South Texas Project  
Units 3 and 4  
Docket Nos. 52-012 and 52-013  
Revised Response to Request for Additional Information

**RAI 03.08.04-18, Revision 1, Supplement 1****QUESTION:****Follow-up to Question 03.08.04-2 (RAI 2964)**

### **Description of Changes to the Radwaste Building General Arrangement Drawings**

FIGURE 1.2-23A RADWASTE BUILDING AT ELEVATION -1700 MM

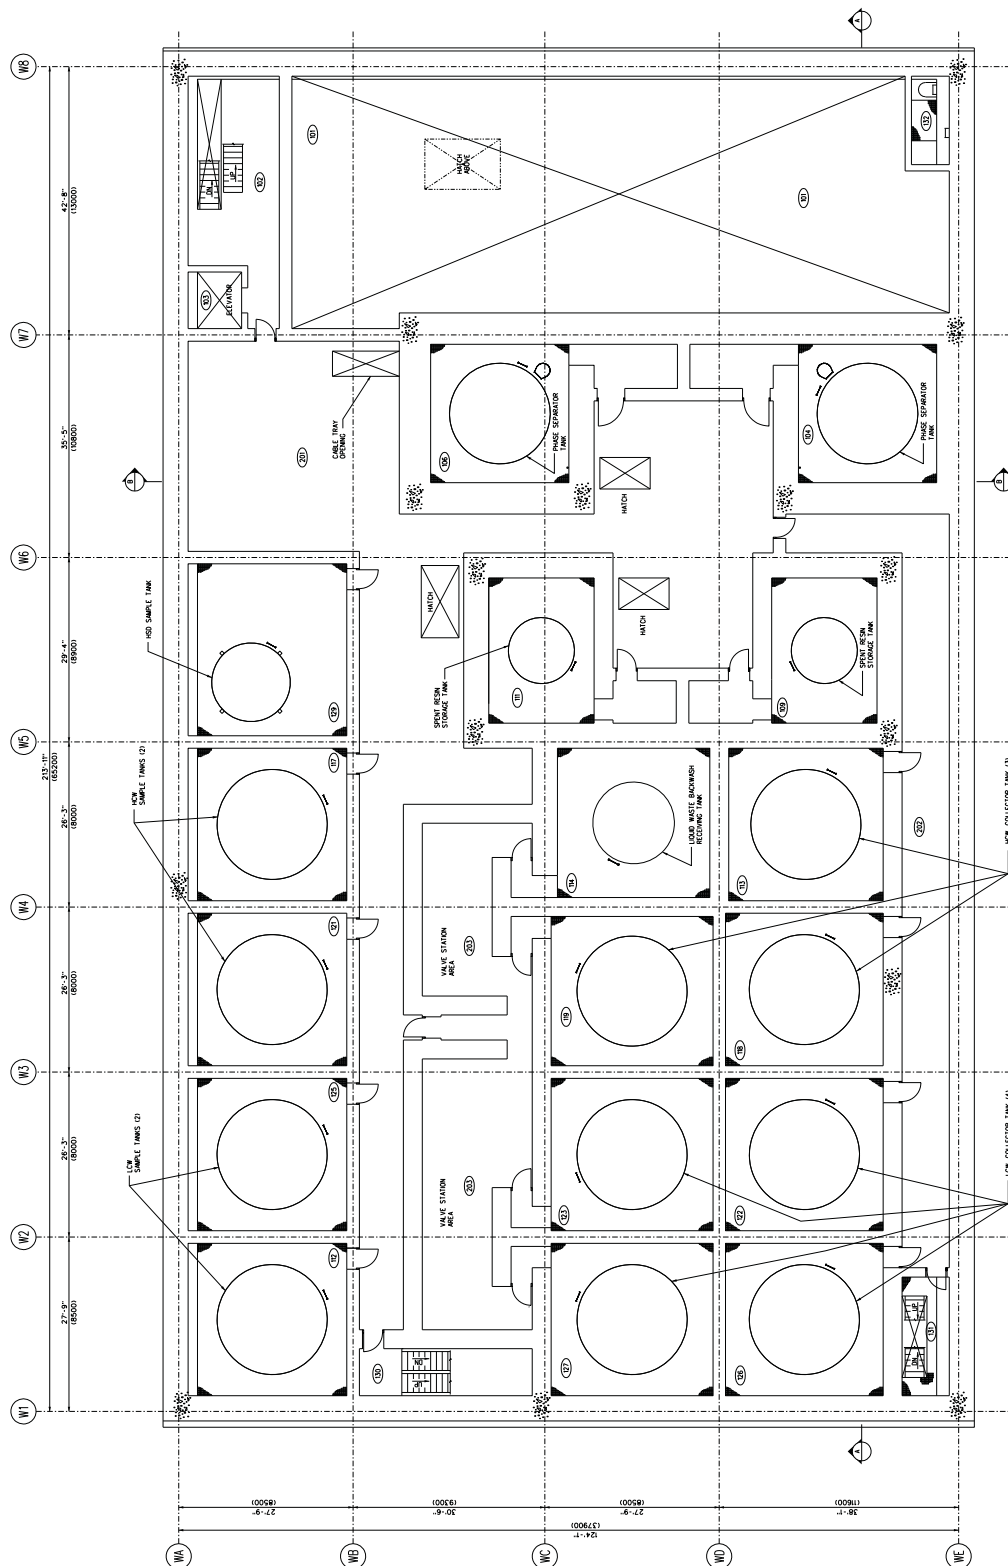
- The phase separator tanks and associated pumps are moved from the west end of the building to the east end. This change shortens the piping runs from the radwaste piping tunnel (which provides the connection to the Reactor Building and Turbine Building) to the tanks and from the tanks to the dewatering equipment. The shorter piping runs for this system, which has a high solids content, reduce demand on components of the system, helps prevent crud buildup, and minimize and localize the sources associated with the phase separator tanks.

- The decant pumps for the phase separator and spent resin tanks were separated from the transfer pumps and placed in separate rooms for ALARA purposes (see “Partial Floor Plan” on Figure 1.2-23a). The decant pumps are expected to handle liquid with a much lower activity than the transfer pumps, so this is an implementation of the ALARA concept of separating low activity components from high activity components.

- The two rows of tanks were shifted to the west against the west wall to utilize the space formerly occupied by the phase separator tanks. The corridor along the west wall, which was used to access the phase separator tanks, was eliminated as no longer necessary, and to save space. The removal of the corridor required the addition of a stairwell in the northwest corner of the building for life safety reasons.

- The liquid waste (LW) backwash receiving tank and associated pumps were moved from the northwest corner of the RWB to the approximate center of the RWB adjacent to the west wall of the spent resin tanks. This move also locates this tank near the other sludge tanks so that all sludge tanks are located in the same area of the RWB. This move shortens the pipe runs from the processing equipment located on the floor above, which is the primary input to the tank. This also locates the LW backwash receiving tank closer to the phase separator, which is used to process the contents of the LW backwash receiving tank. In a manner similar to the relocation of the phase separator tank, the shorter piping runs for this system, which has a high solids content, reduce demand on the components of the system, help prevent crud buildup, and minimize and localize the sources associated with the LW backwash receiving tank.

- The row of sample tanks along the north wall was shifted west to the west wall to utilize the space formerly occupied by the LW backwash receiving tank. A wall was added between the two high conductivity waste (HCW) sample tanks to provide shielding between two passive components. This provides shielding that may be required in the unlikely event that one of the HCW sample tanks becomes contaminated to ensure that the radiation zones are not adversely impacted.

- The hot shower drains (HSD) receiver and sample tanks and pumps were moved from the center of the RWB to the north wall east of the sample tanks. This move makes room for the LW backwash receiving tank in the center of the RWB and utilizes space vacated by the relocation of the LW backwash receiving tank. The HSD receiver and sample tanks are low activity tanks, and this move groups them with the low activity sample tanks. Both tanks and the pumps are accessed from El 12'-0", and the lower region serves as a stainless steel lined leak retention space similar to the other tank rooms (this is unchanged from the current design).

- The chemical drain tank and pumps were moved from the second floor (Figure 1.2-23b) to the basement (Figure 1.2-23a) along the north wall east of the HSD tanks. This made use of available space and freed up space for a valve aisle on the second floor (this places the valves and pumps in separate rooms to reduce radiation exposure). When combined with the relocation of the HSD tanks, all low activity tanks are located along the north wall of the RWB (this will facilitate operations and reduce operational radiation doses).

FIGURE 1.2-23B RADWASTE BUILDING AT ELEVATION 5300 MM

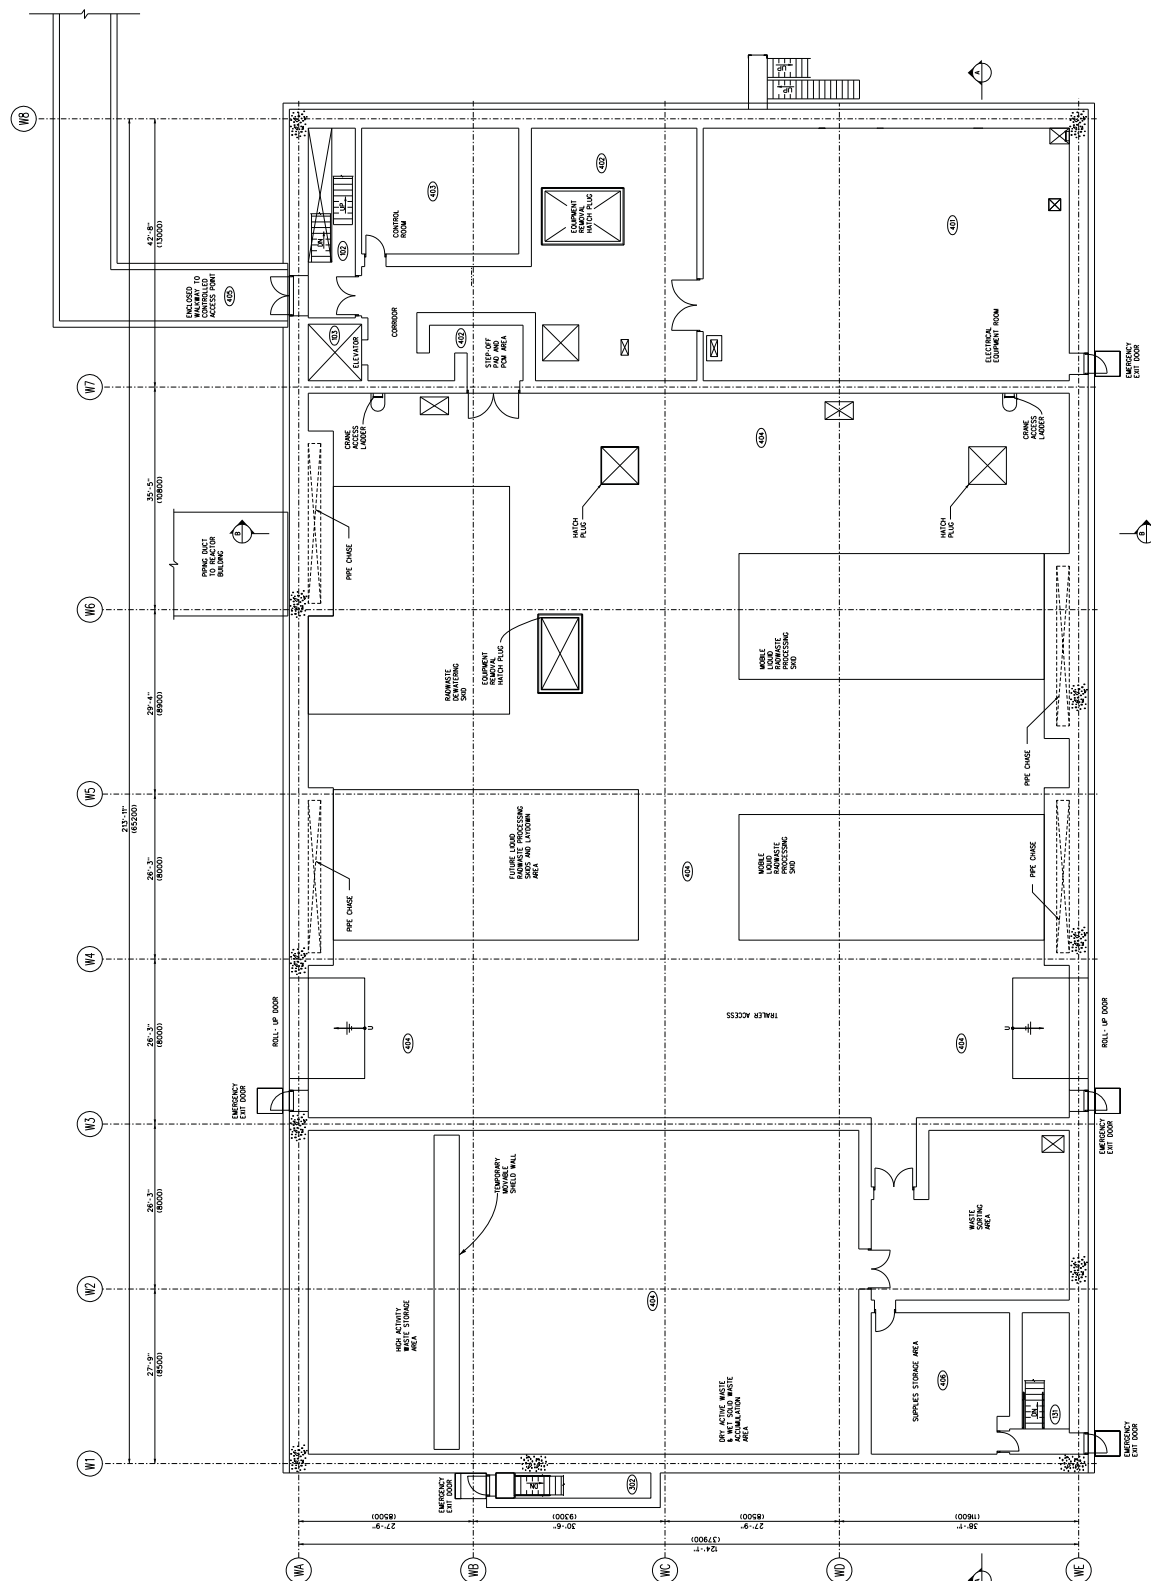
- The electrical equipment room was moved from the El 5300 mm floor (Figure 1.2-23b) to the Grade floor (Figure 1.2-23c) to locate it adjacent to the control room (this places the clean electrical areas in adjacent locations). The area on the El 5300 mm floor is now used as a cable spreading area (this will facilitate construction and maintenance).

FIGURE 1.2-23E RADWASTE BUILDING, SECTIONS A-A, B-B (SHEET 1)

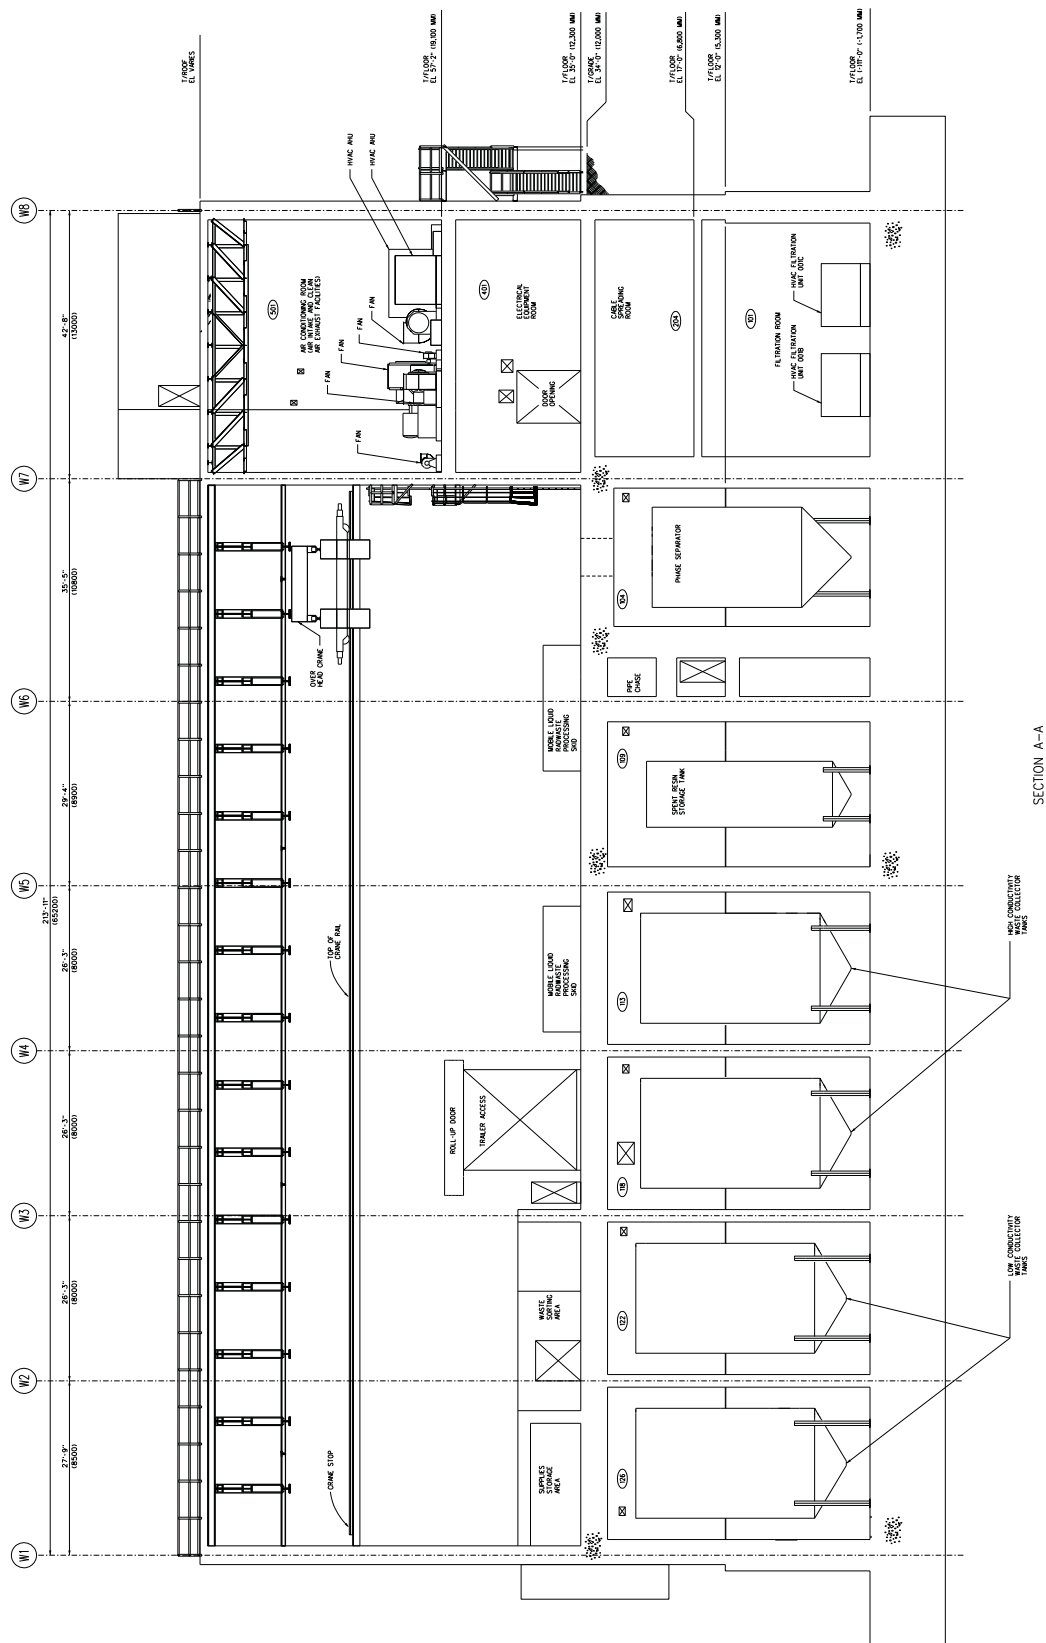
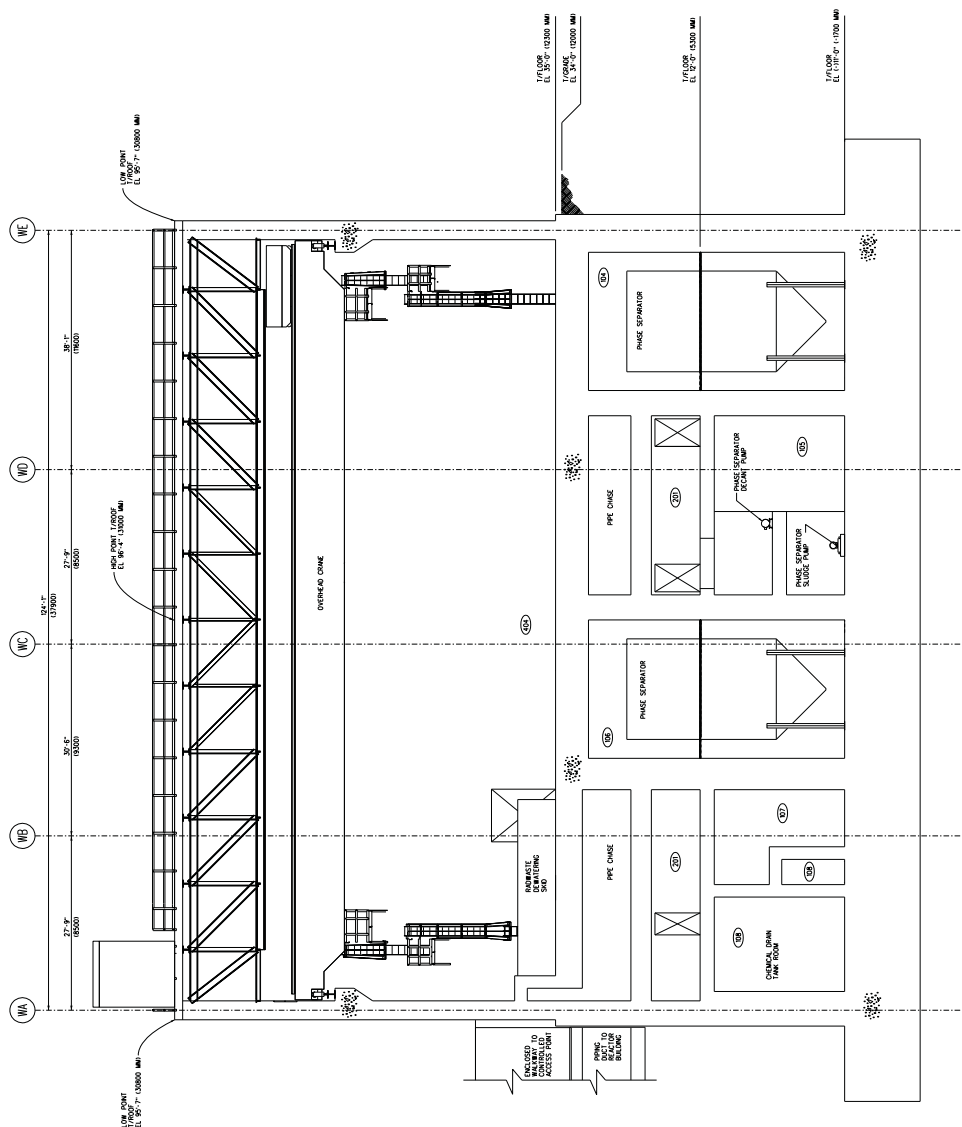
- The height of the roof above the ground floor has increased from 44'-0" to 61'-4" to accommodate the size and lifting height requirements of the overhead crane. This will improve the operability of the facility (e.g., radioactive waste cask loading operations) by increasing the crane hook clearance.
- The changes in thickness of the RWB outside walls and the configuration of the basement as shown in the revised Figure 1.2-23e are based on the detailed structural analysis. The interior dimensions of the RWB are not changed.

- The section views on Figure 1.2-23e were separated onto two sheets (maintaining the same figure number) to improve legibility as required for the larger scale used for the revised figures.

FIGURE 12.3-66 RADWASTE BUILDING, AREA RADIATION MONITORS AT ELEVATION 5300 MM

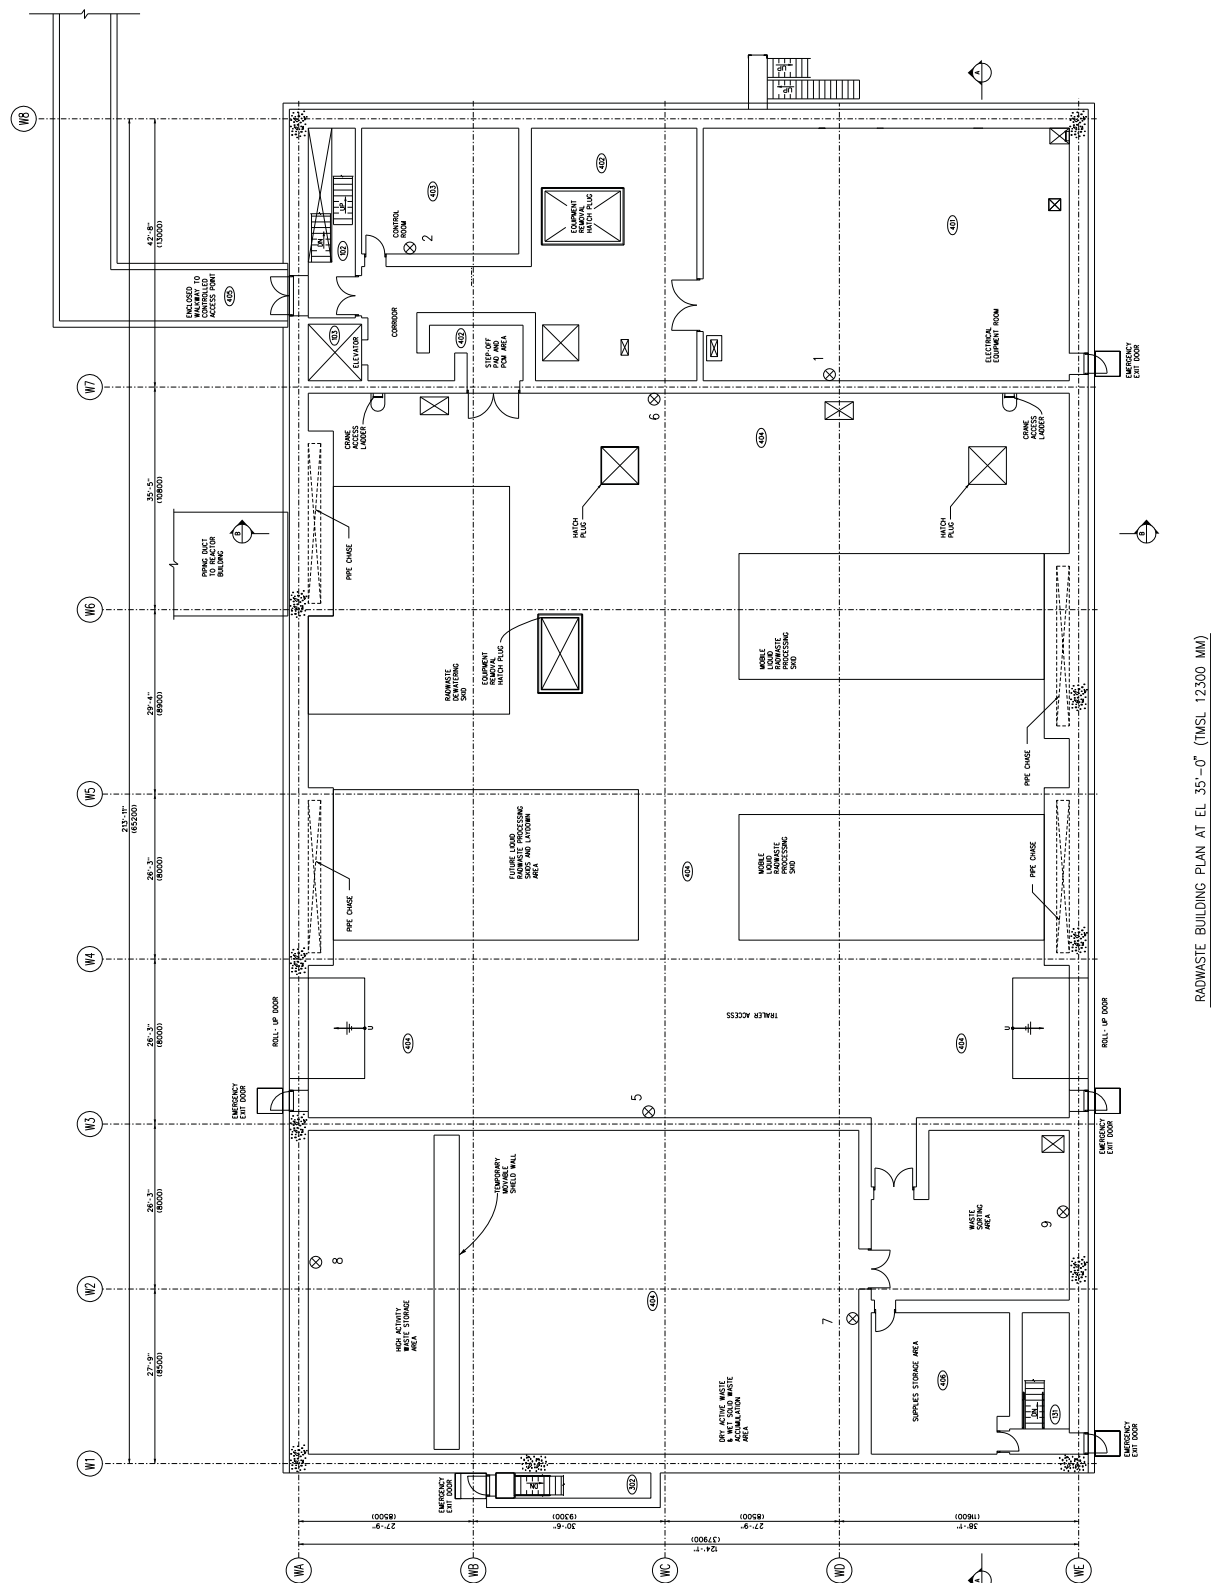
- The Electrical Equipment Room radiation monitor (No. 1) is removed from this figure, and is now shown on Figure 12.3-67 because the room was moved to that elevation. It serves the same function.
- The phase separator tank room monitors (No. 10 and 11) were moved from the west end of the RWB to near the east end because the phase separator tank rooms were moved. The radiation monitors are still located inside the phase separator tank rooms. They are relocated with the tanks and serve the same function,
- The spent resin tank room monitors (No. 3 and 4) were moved west one column row because the spent resin tank rooms were moved. The radiation monitors are still located inside the spent resin tank rooms. They are relocated with the tanks and serve the same function.
